Access Compliance Report

Public Rights-of-Way

Intersection ID: 10019873	Main Street: ARCHDALE_DR	Cross Street: N/A	Location: S
ADA ID: D1720D1EDFC1	Ramp Type: PerpDiag	Initial Pass/Fail: Fail	Overall Compliance: No
Severity Score: 42.5			
Codes/Mitigation Info/Possible Solution		Field Measurements/Component Compliance

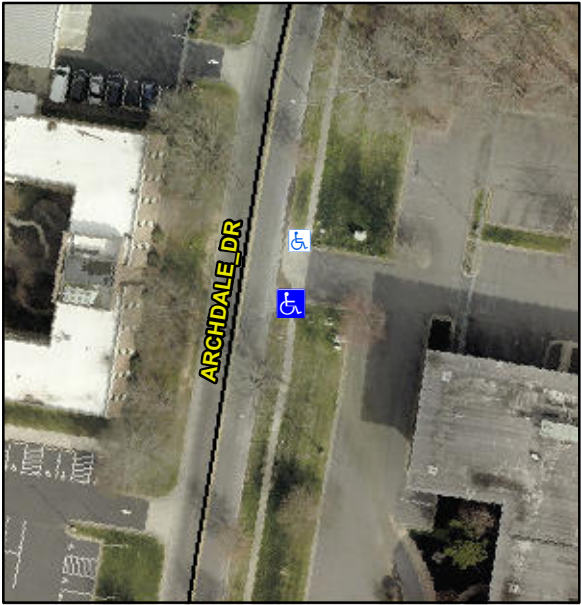
Possible Solutions:	Compliance	Description	Data	Compliance	Description	Data
	Remove & Replace Curb Ramp With Two New Directional Ramps or Equivalent.	N/A	Ramp Length (in)	84.0	No	Ramp Slope (%)	17.3
		No	Ramp Width (in)	32.0	Yes	Ramp XSlope (%)	0.3
		N/A	Flare Type LT	N/A	N/A	Flare Type RT	N/A
		N/A	Flare Slope LT (%)	N/A	N/A	Flare Slope RT (%)	N/A
		N/A	Flare Traversable LT?	N/A	N/A	Flare Traversable RT?	N/A
		N/A	Landing Length (in)	N/A	N/A	DWS Provided?	N/A
		N/A	Landing Width (in)	N/A	N/A	DWS Contrast?	N/A
		N/A	Landing Slope (%)	N/A	N/A	DWS Length (in)	N/A
		N/A	Landing X Slope (%)	N/A	N/A	DWS Full Width?	N/A
<p>Surveyor Notes:</p> <p>N/A</p> <p>PROW/ADA:</p> <p>Not Found, R304.5.1, R304.2.2</p>		N/A	Landing Curb? (Y/N)	N/A	N/A	DWS Offset (in)	N/A
		N/A	Shared Landing?	N/A			
		N/A	Gutter Ponding?	N/A	N/A	Gutter Slope (%)	N/A
		N/A	Gutter Lip Ht (in)	N/A	N/A	Gutter X Slope (%)	N/A
		N/A	Painted X Walk1?	No	N/A	Painted X Walk2?	No

X Walk 1 Direction	To N		X Walk 2 Direction	To W
		N/A	X Walk 1 Width (in)	N/A	N/A	X Walk 2 Width (in)	N/A
			X Walk 1 Slope (%)	6.6		X Walk 2 Slope (%)	1.2
			X Walk 1 X Slope (%)	4.4		X Walk 2 X Slope (%)	9.0
		N/A	Ramp inside XWalk1?	N/A	N/A	Ramp inside XWalk2?	N/A
<p>Street 1 Name</p> <p>Stop Condition-Street 2</p> <p>Street 2 Name</p> <p>Stop Condition-Street 1</p>	ENTRANCE <p>None</p> <p>ARCHDALE DR</p> <p>None</p>		Road Slope (%)	0.3	N/A	Clear Space?	N/A
			Road X Slope (%)	7.9	N/A	Clear Space to XWalk (in)	N/A
		N/A	Any Obstructions?	N/A	N/A	Storm Grate/Utility Hazard?	N/A
			Obstruction Type			Storm Grate/Utility Type	
					N/A		N/A
					Yes	Surface Condition? (G/P)	Good
Total Cost:		\$	3200.00
